Proposed Liquid Waste Treatment Plant  
SSD 8304  
**Response to Submissions Report**

DGL Group Limited  
(Formerly Hydromet Corporation Pty Limited)  
201 Five Islands Road Unanderra, New South Wales  
Planning Plus (NSW) Pty Ltd  
Project 20105– December 2021

1 % AEP Flood Depths and Spot Flood Levels (m AHD)

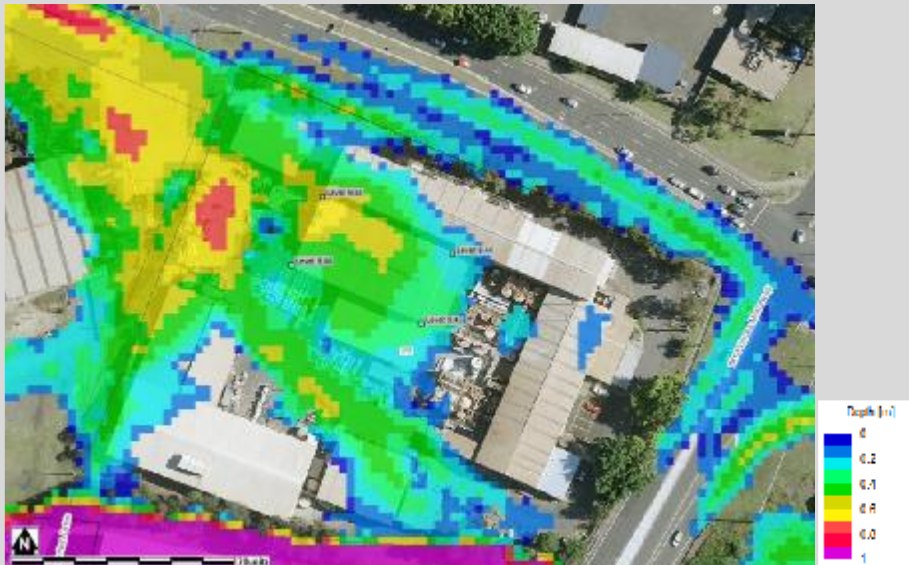
- Council's adopted Allans Creek Flood Study dated 2019 indicates a significant flood flow path through the site flowing adjacent to and around the existing building within which a liquid waste treatment plant is proposed (i.e., 'Building E'), with predicted flood levels and corresponding above floor flood depths in existing Building E being as per the table below.

10 % AEP (10 year ARI)	1 % AEP (100 year ARI)	PMF (Probable Maximum Flood)
Flood Level (m AHD)*	9.53	9.84	10.43
Above Floor Flood Depth (m)**	0.35	0.66	1.25

\*The maximum flood level at Building E – predicted by Council's adopted Allans Creek Flood Study dated 2019.

\*\*Above floor flood depth determined using the surveyed finished floor level for Building E (RL 9.18 m AHD) shown on the site survey plans appended to submitted flood risk assessment report by SitePlus.

All development engineering and flood comments have been addressed in consultation with Council's Senior Stormwater Development Engineer Matthew Carden.

A revised Flood Risk Management Report was prepared and sent to Council for comment on 19 August 2021. Council responded that the report resolved Council's flooding related concerns. Council would provide flooding related conditions once the application and amended Flood Risk Management Report was formally re-referred to Council by DPIE.

A copy of the revised Flood Risk Management Report is located in [Attachment E](#).
